Report on a Publicly Notified Resource Consent Application

(Section 42A)

Application Reference:	RMA/2017/1276
Applicant:	Halo Media Ltd
Site address:	65 – 67 Victoria Street, Christchurch
Legal Description:	Lot 1 DP 484488
Proposal:	Establish a 46m ² LED billboard on the side of an existing multi-story building at 65 – 67 Victoria Street for off-site advertising.
Zoning:	Christchurch District Plan: Commercial Central City Business
Overlays and map notations:	Category 2: Lower Noise Level Entertainment and Hospitality Precincts, Central City Building Height 17m Overlay, Central City Outer Zone, Liquefaction Management Area
Activity Status:	Christchurch District Plan: Discretionary Activity
Submissions:	Two in support Four in opposition (One of those submitters in opposition may consider presenting a joint case at the hearing if others made a similar submission)
Date of Hearing:	20 th December 2017
Recommendation:	Decline

APPENDIX FIVE: - IMAGE OF PROPOSAL

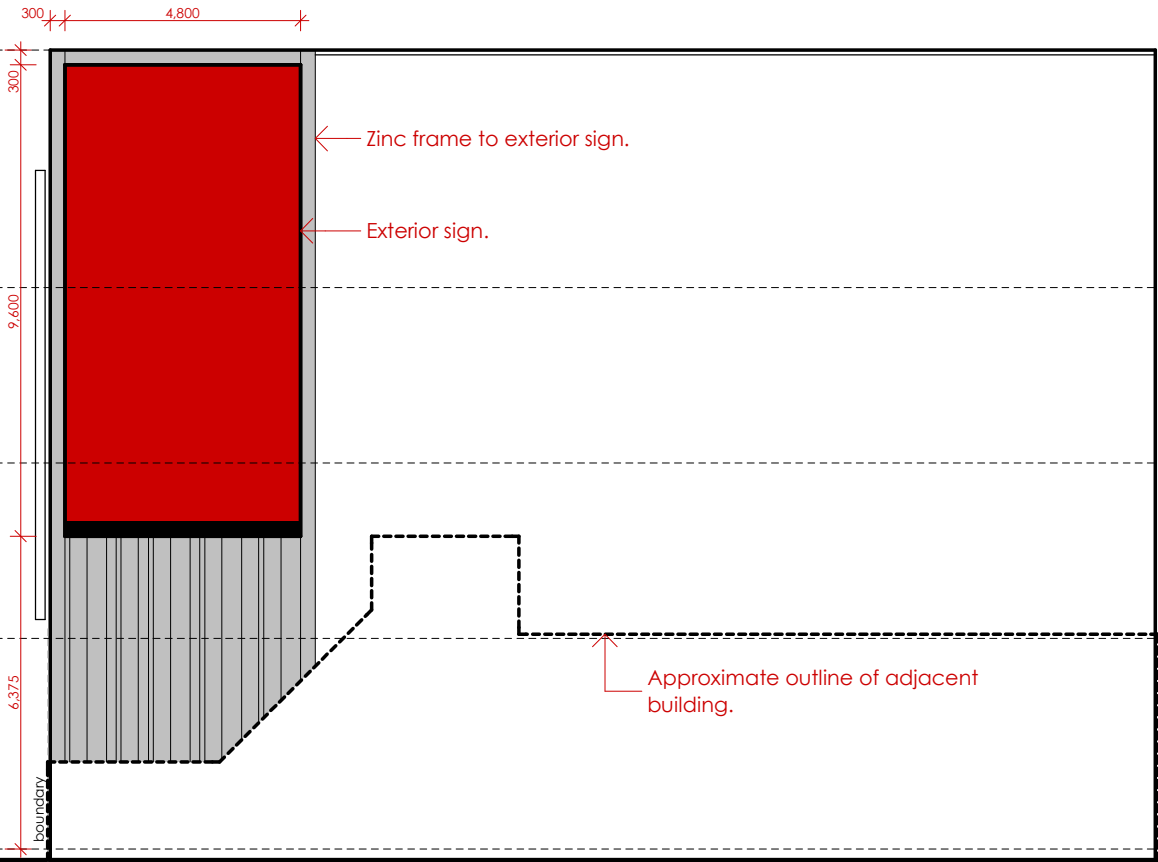
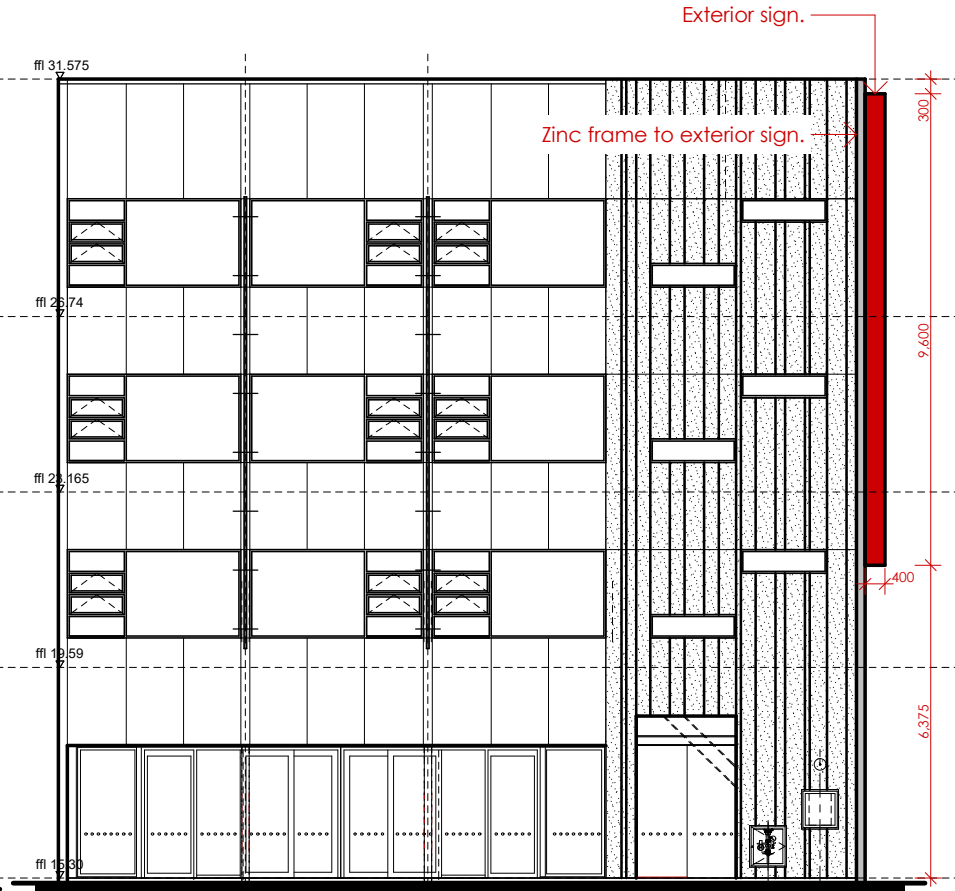
69. The billboard is proposed to be 46 m² with the top of the billboard being approximately 16 m at its highest point on the side wall of a modern four storey building. As previously established, only 8 m² of signage at a maximum height of 9 m is permitted by the Christchurch District Plan for the application site. The proposal clearly exceeds these requirements, with the proposed billboard being over five times in area and being almost double in height when compared to what the District Plan permits.
70. When considering the proposed location and the context of the immediately surrounding environment, the billboard will be of a significant size, height and scale in relation to its setting and as such appear particularly prominent from the north along Victoria Street and those surrounding properties bound by

80. I agree the billboard will be prominent. This is reinforced through the district plan where the scale of permitted signage associated with the site is equivalent to 8m² and to be at a maximum height of 9m above ground. The proposal is for over five times the permitted area of signage and double in height. I however do not agree that the billboard won't be dominating. I consider that the sign will be both prominent and dominant particularly given the height and area of the billboard and the nature of the receiving environment⁴.

107. Mr Hattam notes the proposed billboard is of a similar width to a building module of the building on which the billboard is to be attached to which is a benefit, however with regards to height, the proposal is well less integrated. Mr Hattam therefore considers that while the applicant has made some effort at integrating the sign into the building, the design is not yet successful which, is principally a matter of its size in relation to the building. Furthermore, the proposal lacks any further detail and does not match the articulation of the host building, or recognise the coherence of the building, again being principally a matter of size.

However, the proposal lacks any further detail and does not match the articulation of the host building or recognise the coherence of the built form (for instance the presence of horizontal elements such as the division between floors). This is principally a matter of its size.

In my opinion, although the applicant has made some effort at integrating the sign into the building with the revised proposal, the design is not yet successful and this is principally a matter of its size in relation to the building and its articulation.
